June 12, 2018

Subject: 24 School Street – Mounding Calculations/Stormwater Review

We received and reviewed the second review comments on groundwater mounding calculations/stormwater by Nover-Armstrong Associates, Inc. (NAA) dated June 6, 2018. The groundwater mounding analysis has been updated to incorporate the recommendations in the review comment letter. This letter briefly addresses the comments in the same sequence as in the comment letter by NAA. To facilitate the next round review, we quoted the comments first in *italic* and then followed by our response in **Bold**.

Grading Profiles

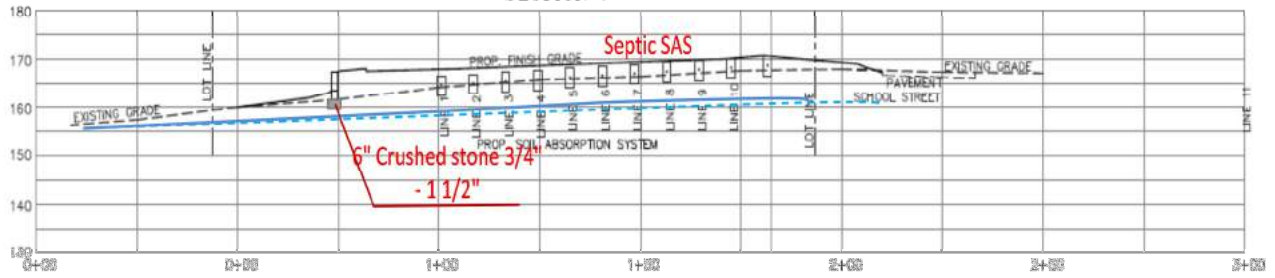
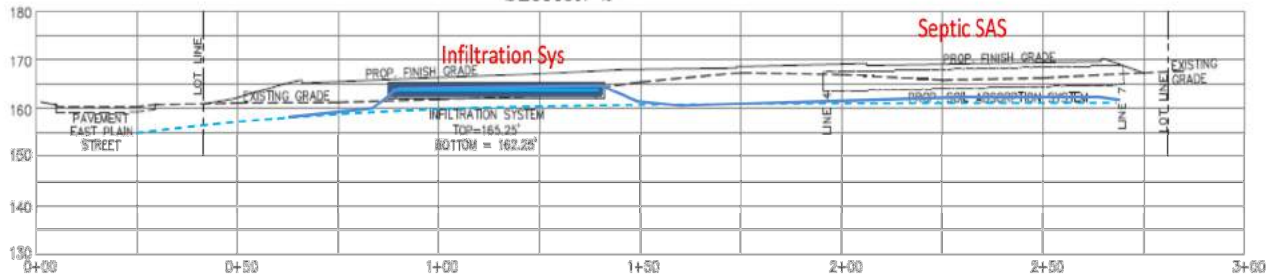
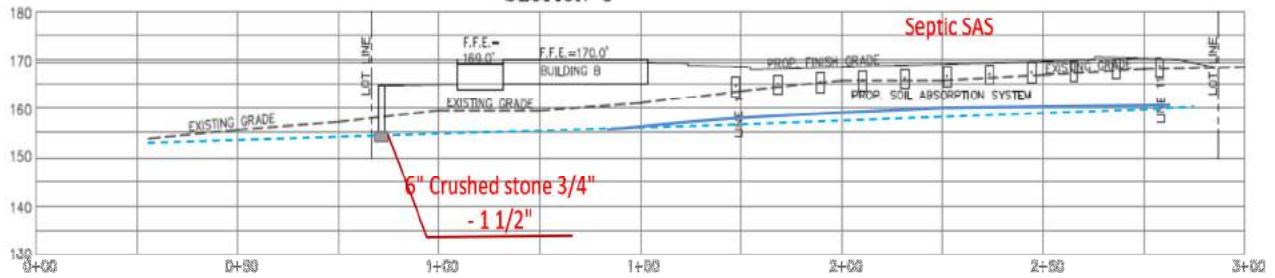
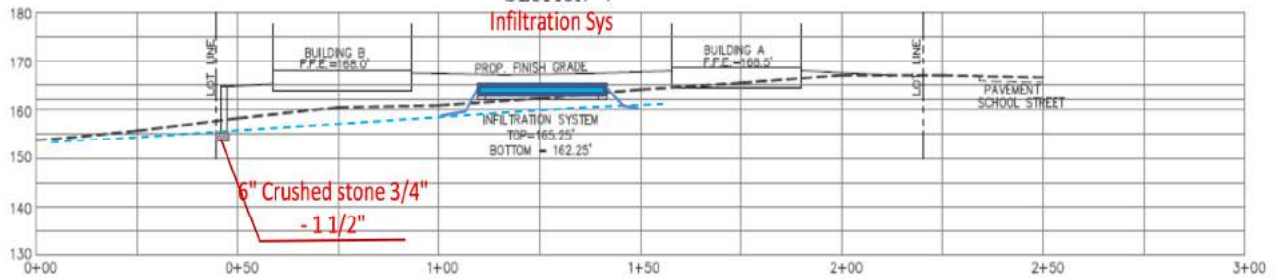
4.2 *Nover-Armstrong cannot however confirm that there will be no impact on the stormwater mounding height from the proposed building foundations. The foundations are less than 20 feet from the infiltration system and would appear to have frost wall footings lower than the elevation of the estimated mound height.*

- 4.5 *CREATIVE estimated groundwater mounding under the SAS and stormwater infiltration system will have minor impact on each other's mounding heights. Four cross sections were provided with the Letter to Wayland Conservation Commission, prepared by CREATIVE Land and Water Engineering, LLC; dated May 8, 2018 showing the mounding impacts on each other.*

Response: As for the frost wall footing concern on stormwater mounding height, we checked the depth when we plotted the four profiles as requested last time and addressed the unlikely impact as the site will have significant fill, the footing of the wall will be located above water table. The mounding height at the foundation reduces to about 0.5 ft while the water table also pitch down toward the wetland, the footing depth will be 4 ft below the garage floor 167.5 ft, which is at 163.5 ft. This is about 3 ft above the mounded water table at the footing, which is below 160.5 ft. So, the foundation will have no impact on the mounding. See also our response in the last correspondence on this concern "[F]our profiles across septic SAS and the stormwater infiltration area are plotted to show that the groundwater movement and mounding will not be impacted by the retain wall or building foundation as there will be no basement for all the buildings, which will built on quite amount of fill above groundwater. See the profiles for details. As the retaining wall footing in some locations may get close the high water table, it should be checked in the field to make sure the retaining wall footing will be set at or slightly above the seasonal high groundwater table to assure the proper groundwater movement. To add a safety factor here, a 6" thick crushed stones is recommended as the subbase of the retaining wall to facilitate the water move, which would be equivalent to more than 3 ft sandy soil flow passing capacity."

Response: No further response needed.

Figure 2. Existing Site Condition Aerial Photo

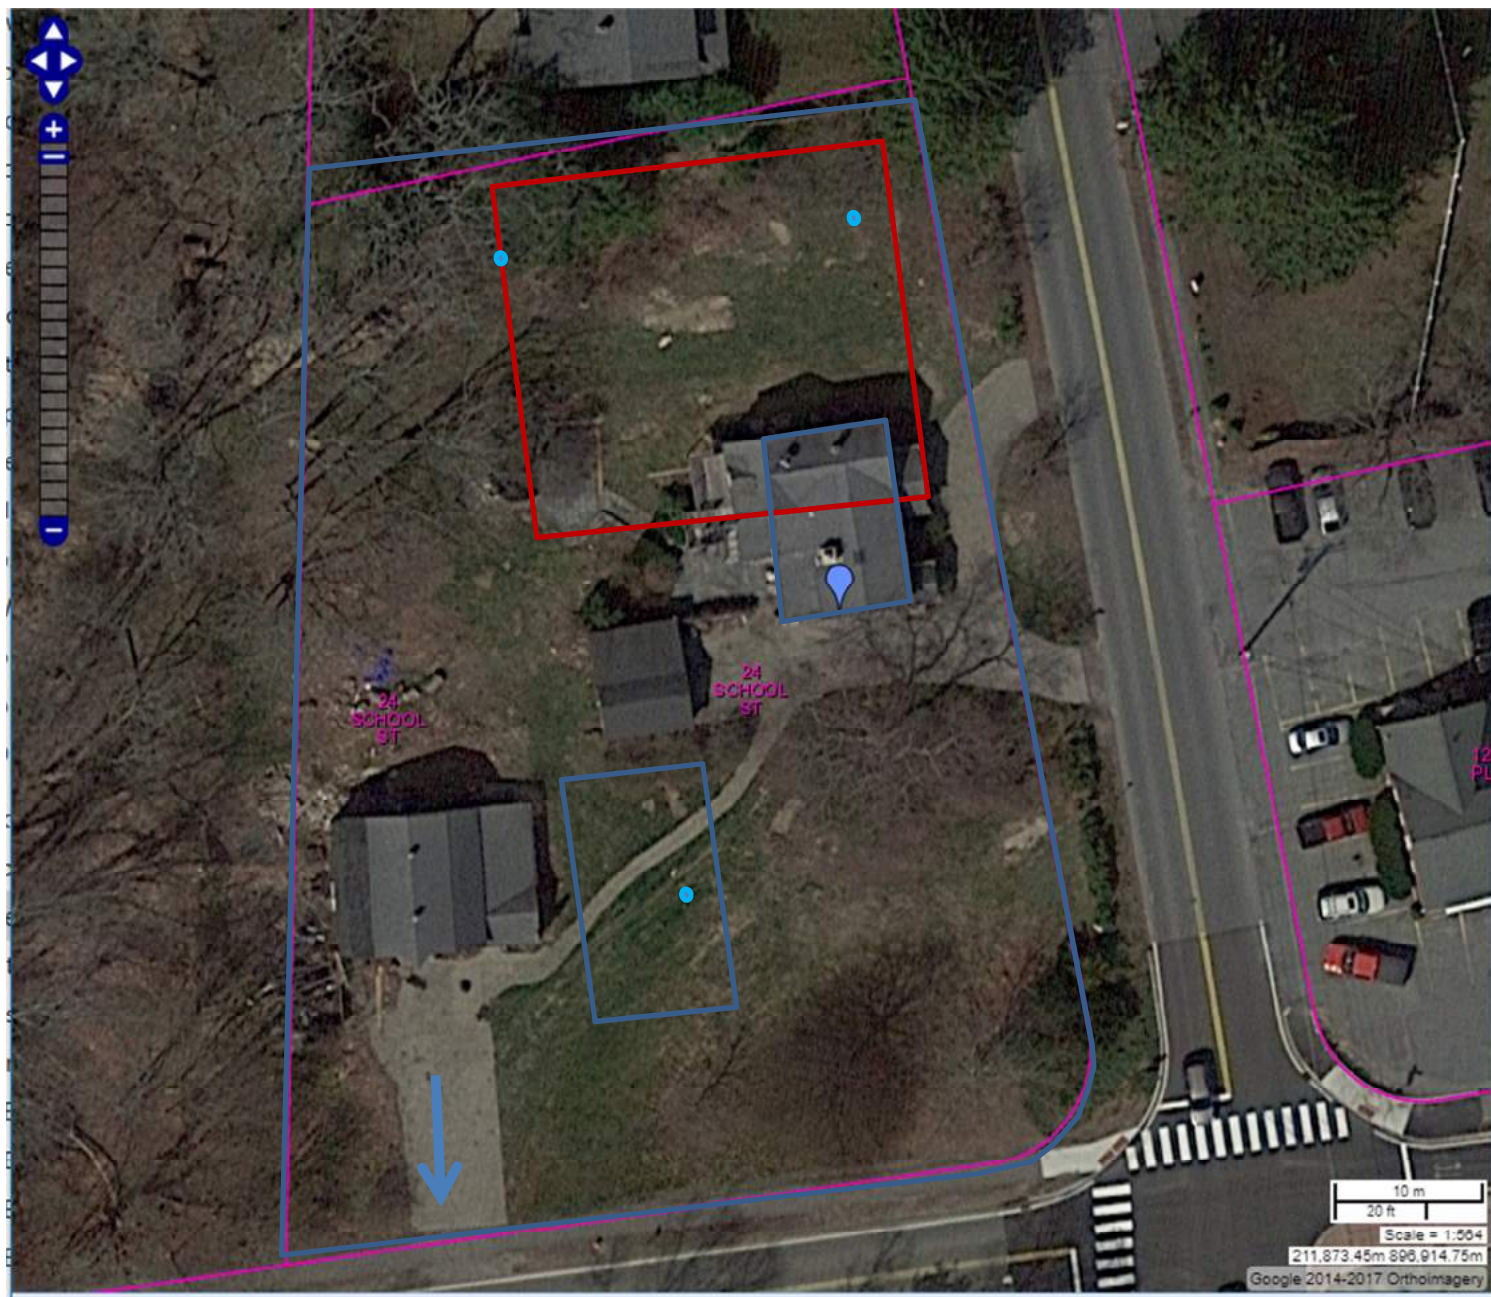
6.1.8 *The grading at the top of the driveway from East Plain Street will allow runoff to by-pass CB 3 and discharge out to East Plain Street.*

Response: This is a small portion that will be handled by the catch basins in East Plain Street as redevelopment condition. See Figure 2 of the existing aerial photo. Existing condition had more impervious area draining to East Plain Street. The proposed condition will reduce impervious area to East Plain Street significantly.
